ADDENDUM NO. TWO

PUBLIC WORKS VEHICLE MAINTENANCE FACILITY

CITY OF SOCIAL CIRCLE, GEORGIA

PROJECT NO. 242774

CITY OF SOCIAL CIRCLE
PUBLIC WORKS DEPARTMENT
INITIAL SESC PLAN
NEW VINE CIRCLE, SOCIAL CIRCLE, GEORGIA 30025

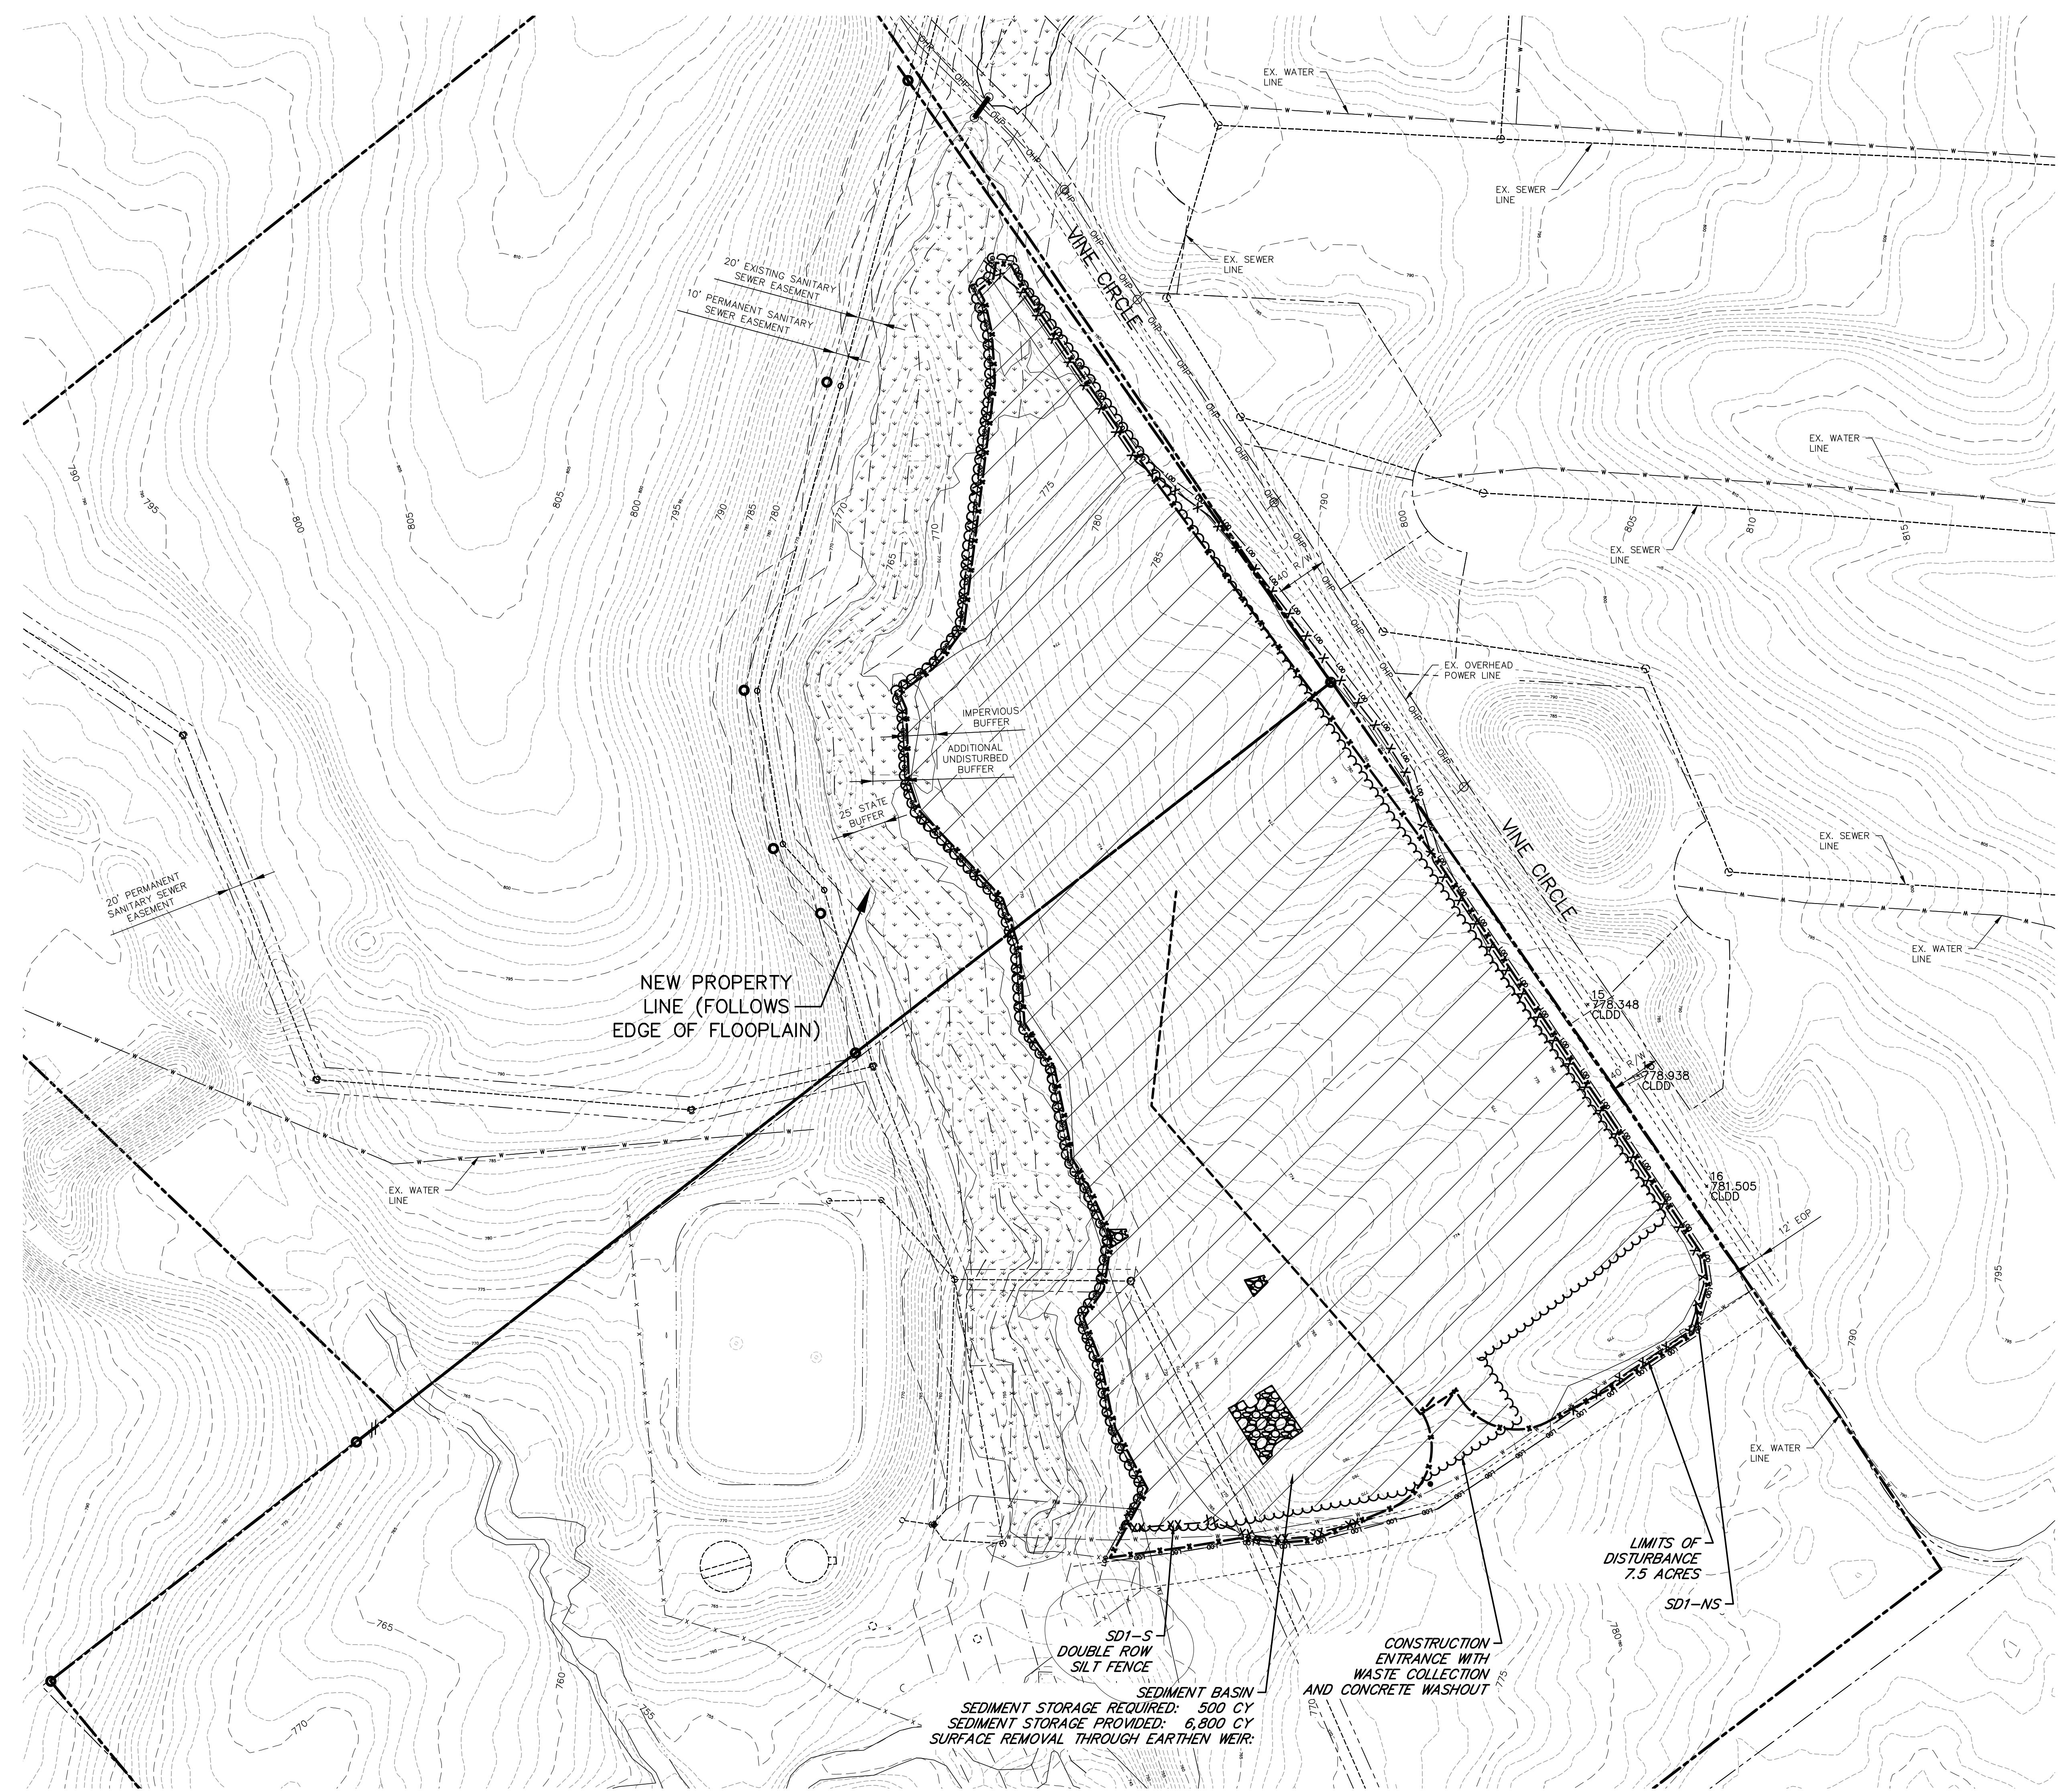
42. Is the Sd1-S layer double row?

Note on sheet E-8 for Sd1-S has been updated to reflect a double row of silt fence. See revised sheet E-8.
